Re: Terminal 4 Stormwater Source Control Measures – 100% Design Plan Sets and Operation and Maintenance Plans for Vegetated Infiltration Basins

1. 100% Plan Set and O&M Plan– Basin M Source Control Measure
2. 100% Plan Set and O&M Plan – Basin K1 Source Control Measure
3. Response to DEQ Comments Matrix on 60% Plan Sets

SHEET
C4.0

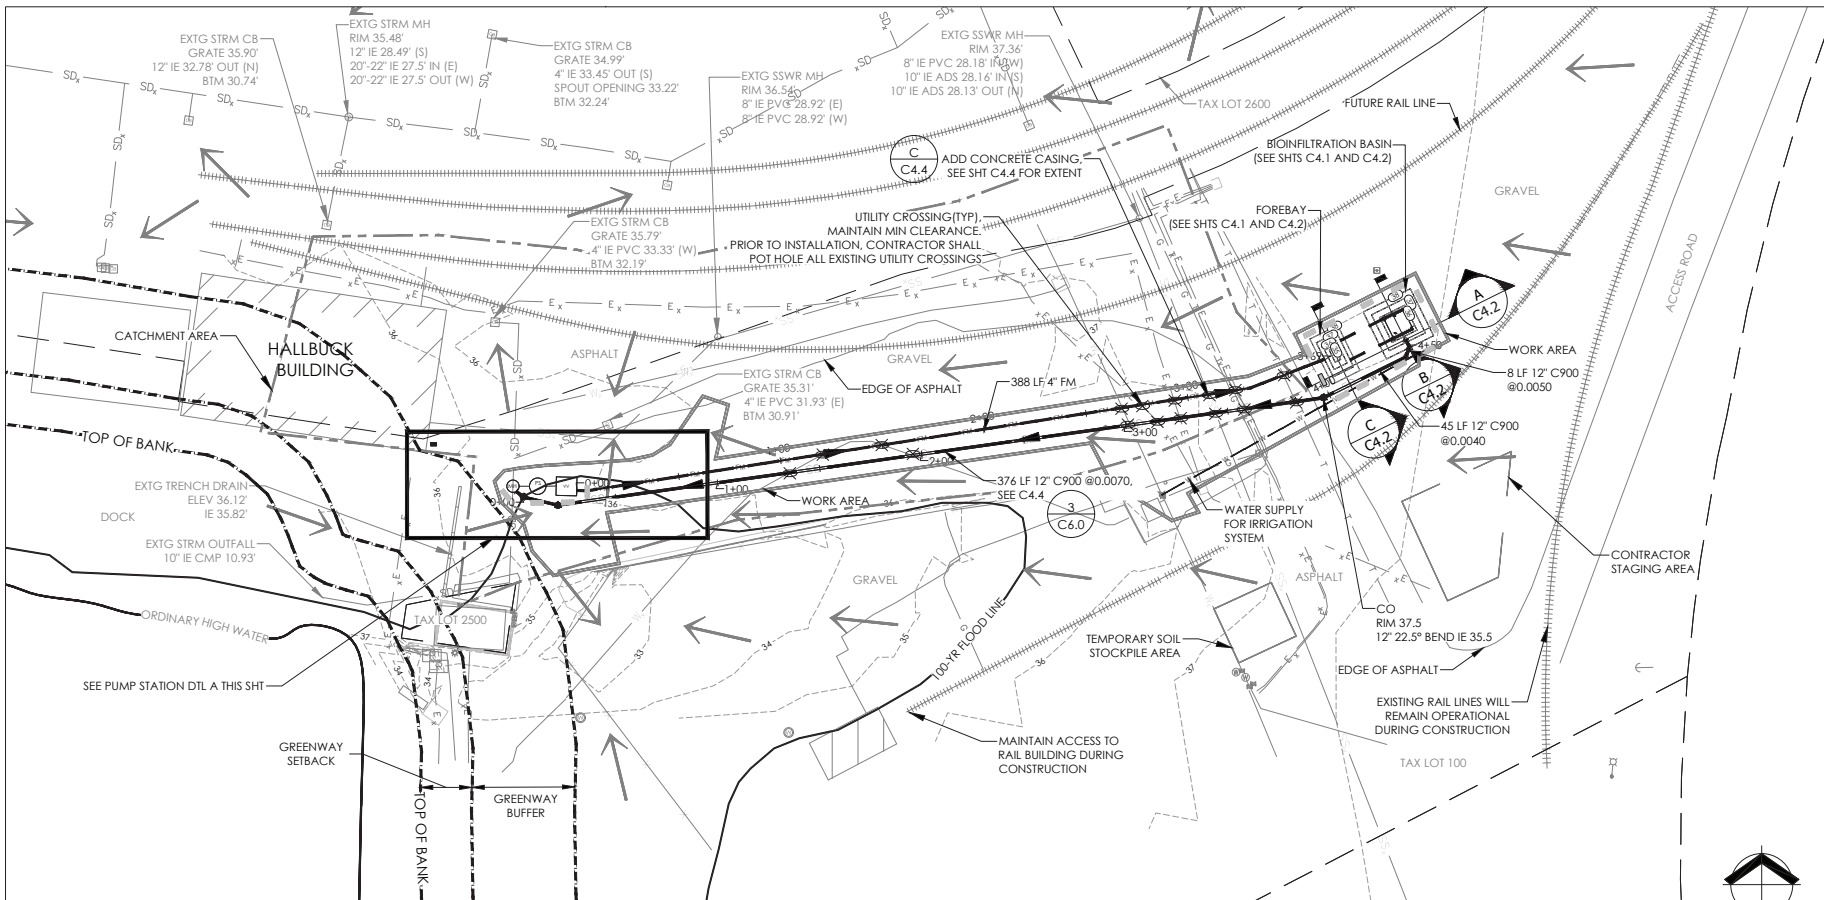
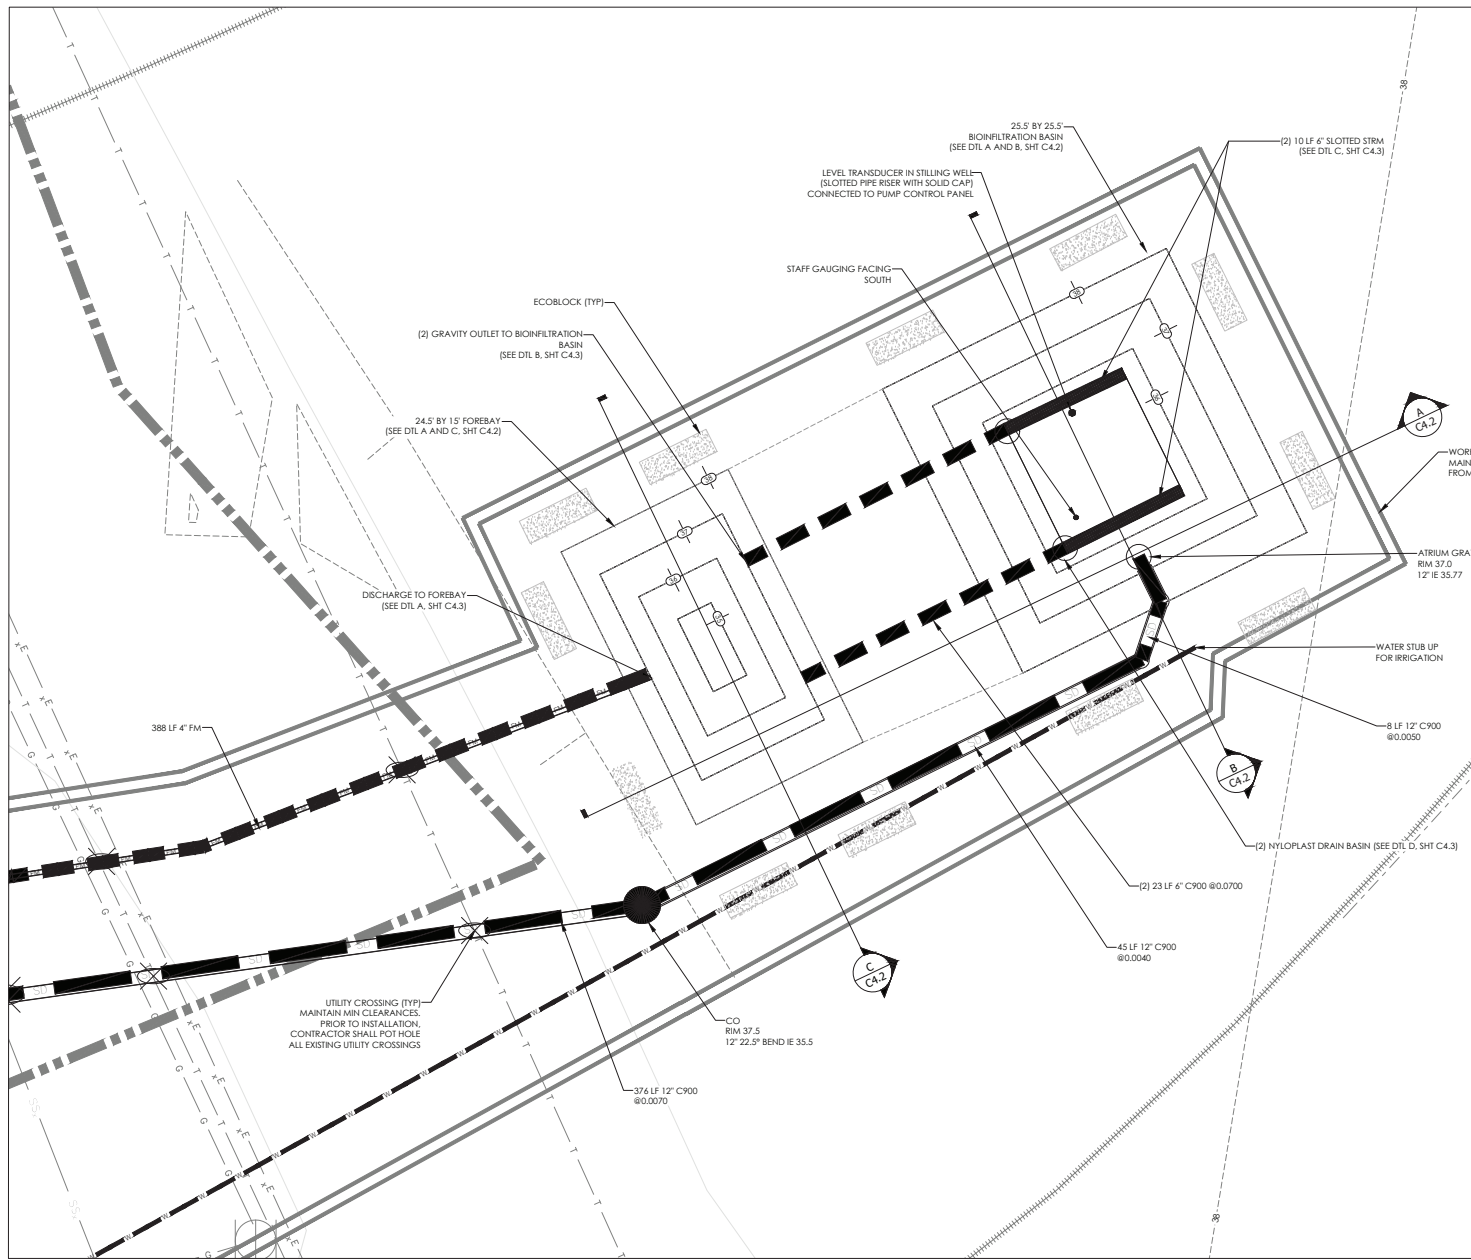
4 - Specific Comments – Basin M	60% Plans Sheet C1.01	4. Sheet C1.01 Erosion and Sediment Control Plan - Please indicate locations for planned soil stockpiles and equipment staging.	Locations of planned temporary soil stockpiles and equipment staging are shown in the 100% design plans (C1.01)
5 - Specific Comments – Basin M	60% Plans Sheets C4.01, C5.01, C6.01	5. DEQ notes that elevations for selected features on Sheet C4.01 Grading Plan, Sheet C5.01 Stormwater System Profile and Sheet C6.01 Civil Details 1 are not consistent. As an example, the bottom elevation of the forebay is shown as 32.19 feet on C4.01 and C5.01 but is shown 32.15 feet on Sheet C6.01. In addition, the force main outlet is shown at an elevation of 33.02 feet (Station 2+1.02) on Sheet C4.01 but as 32.38 feet on Sheet C5.01. If the discrepancies are due to different survey stationing it is not clear from the information provided. Please clarify or correct as appropriate.	The discrepancies noted have been corrected in the 100% design as follows: • <i>Bottom elevation of forebay: 32.19’ (confirmed on sheets C4.01, C5.01, C6.01)</i> • <i>Force main outlet IE: 33.02’ (confirmed on C4.01, C5.01)</i>
